Pre-Plaster Report.

Inspection Date: 5 Feb 2020

Section A - Results of inspection - summary

2.01

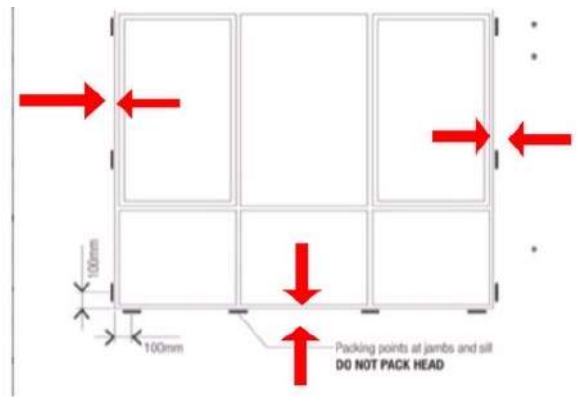
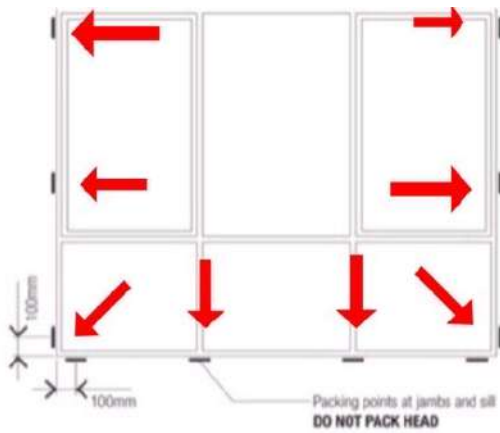
Finding: Window Installation - Gaps To Perimeter Of Windows Defective & Insulation Required As per AS-2047-1999 and the defect clause is below.
All windows must have sufficient gap around them with a minimum of 15mm at the top of the window to the underside of the timber frame.
In this case the defect in discussion is the sides of the window and the bottom of the window DO NOT have a sufficient gap if any to allow for movement and compression of the frame.

ALL WINDOWS with no or insufficient gaps, also as per manufacturers standards is packing to the sides and bottom of the windows as well, must be reworked to allow a recommended of at least 15mm to 20mm of packing.
The packers must be as the manufacturers specifications.

2.02

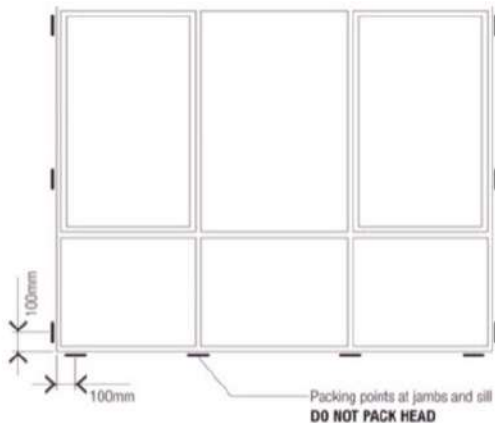
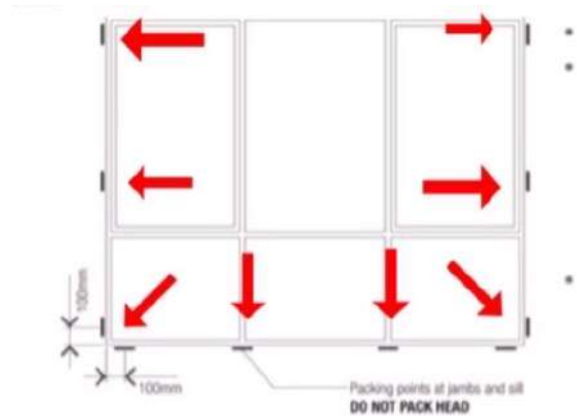
Finding: Windows - No Packing, As Per The Manufactures Specifications. (Or Packing Not Satisfactory)

Windows must be packed at the mullions as specified by the window manufacturers specifications.

In this case the defect in discussion is the sides of the window and the bottom of the window DO NOT have a sufficient gap if any to allow for movement and compression of the frame.

ALL WINDOWS with no or insufficient gaps, also as per manufacturers standards is packing to the sides and bottom of the windows as well, must be reworked to allow a recommended of at least 15mm to 20mm of packing.

2.03

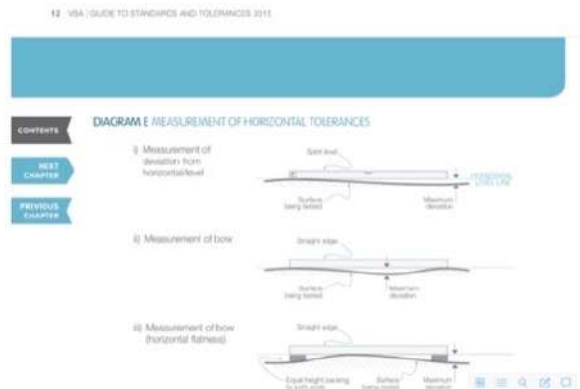
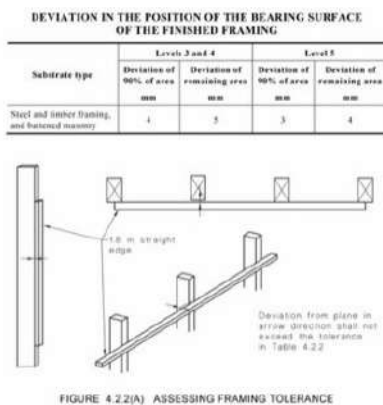
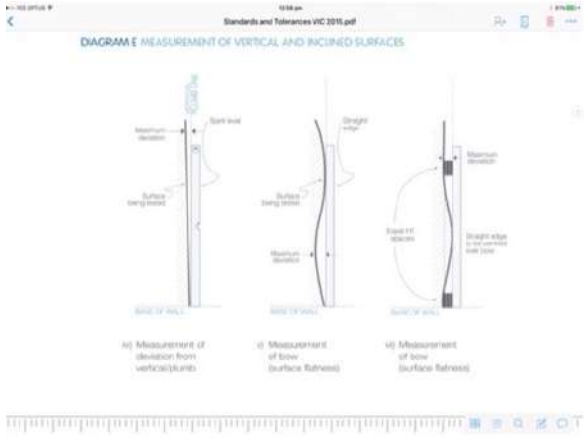
Finding: Frame / Walls - Not Square-Vertical Or Horizontal (max variation is 4mm over 2 mtrs)
It is observed that post/s and wall frame/s are defective as there is a deviation from a vertical or straight plumb line which exceeds 4mm within any 2m of height / length.

This is commonly referred to as a bow in the frame material and/or defective workman. Any bow in excess of 4mm as identified exceeds the allowable Standards and Tolerances and is considered defective.

Any deviation in excess of 4mm exceeds the allowable Standards and Tolerances and is considered a defect.

A registered builder should be appointed to assess the defect and perform rectification works as necessary.

2.04

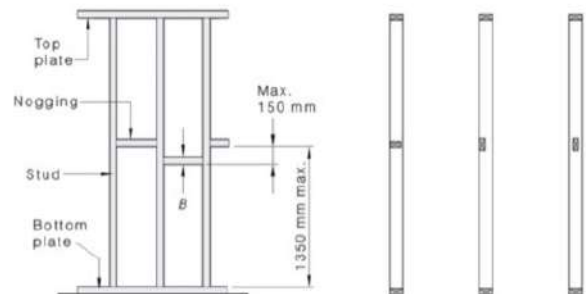
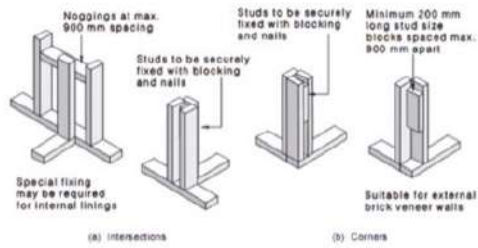
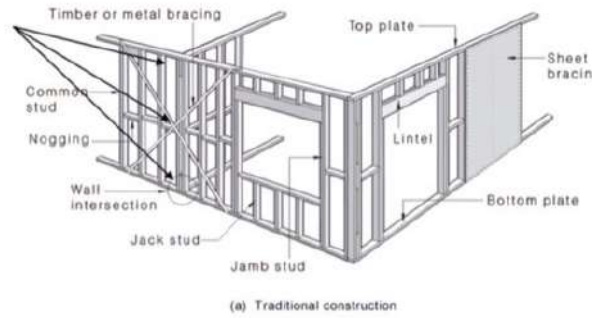
Finding: Noggings - Defective Installation - Missing - Taken Out For Tradespersons Requirements. We refer the builder to AS 1684.2, clause 6.2.1.5 which calls for all noggings to be installed to comply with the Australian Standards. That is into all stud openings, staggered no greater than 150 mm with no opening exceeding 1350 mm in total.

All walls must be installed with noggings no greater that 1350 mm spacing. The intersecting wall connection does not negate this requirement.

As such the continuation of noggings through the intersecting wall area must be installed. This means that one block has to be set at the noggling level. I refer the builder to clause 6.2.1.5.

2.05

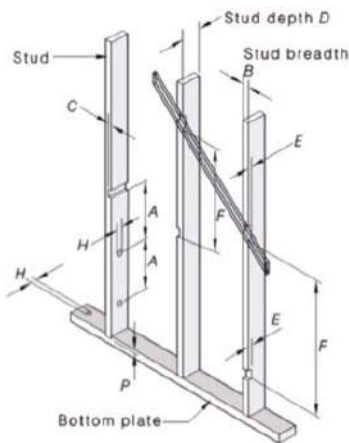
Finding: Holes and notching - insufficient distance and oversized holes.
 It was observed during inspection that the minimum distance between holes for services (electrical and / or plumbing) and notching has not been maintained. The AS1684.2 2010, Page 60 and 61 requires a minimum distance between holes and notching in a 90mm stud and top plates is 270mm apart.
 The standard (table 6.1) states that the distance between holes and other holes or holes to notches in studs can be no closer than 3 x D. This is calculated as 3 x the depth of the material used. In this case 3 x D is 3 x 90mm or 270mm minimum distance apart.

Two Options.

Option One:

Install a noggin on edge hard up against the top plate..Install two nails to each side of the studs and nail two nails into the top plate and into the noggin on edge.

Option Two:

The timber must be replaced and the rough in reinstalled at 270mm separation or the area beside the rough in cleated to add additional support to the stud.

2.06

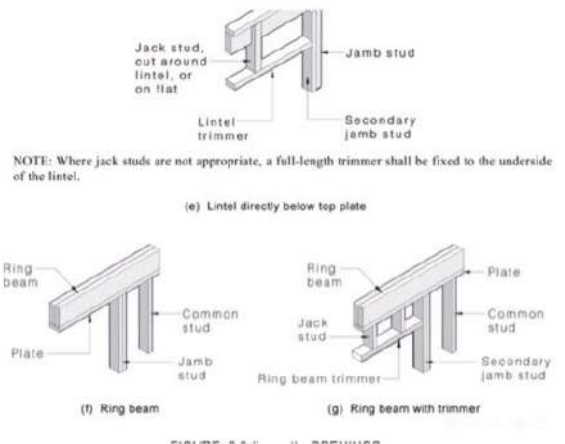
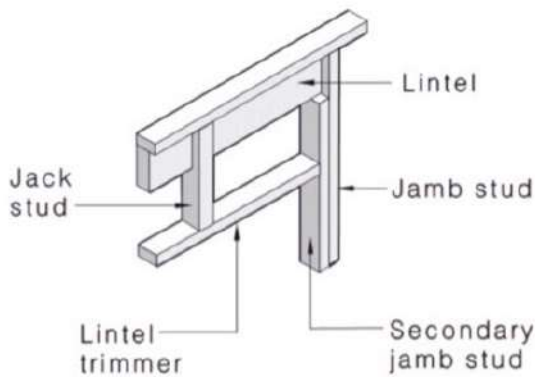
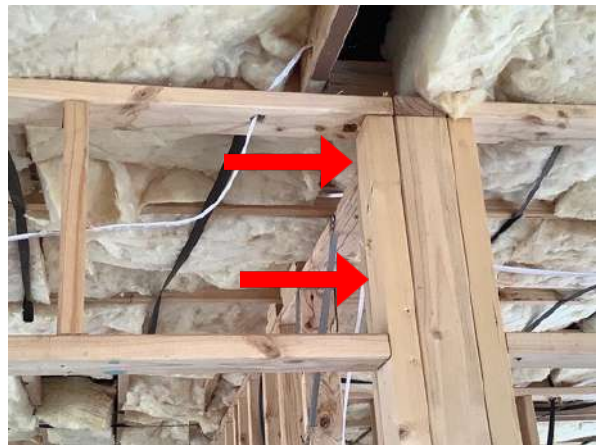
Finding: Door heads Defective (Jamb Studs Defective)
 The door openings have not been constructed in accordance with 1684.4 section 6.2.3 detailing the framing method for openings.
 These areas should be replaced to conform with the above section

2.07

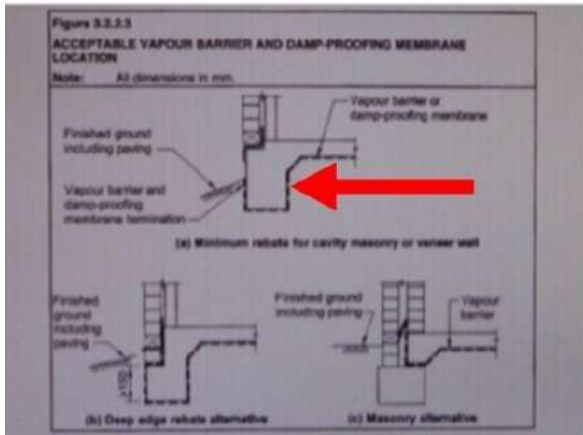
Finding: Vapour barrier - Defective (AS2870- 2011)
The functionality of the vapour barrier to the entire perimeter of the building including, between the the buildings each side of the house is being compromised due to poor workmanship during the installation/construction process.

It is a requirement of AS 2870-2011 5.3.3.4 that vapour barriers are turned up and terminated at ground level above pavement adjacent footing. The vapour barrier is defective if building materials and fill has been left on top of the membrane, as this prevents it from being pulled up against the slab when installing perimeter paving as it is intended to be.

This must be remedied immediately to prevent slab edge
It is a requirement of AS 2870-2011 5.3.3.4 that vapour barriers are turned up and terminated at ground level above paving adjacent footing. The vapour barrier is defective is building material and fill has been left on top of the membrane as this prevents it from being pulled up against the slab when doing perimeter paving as it is intended to be.
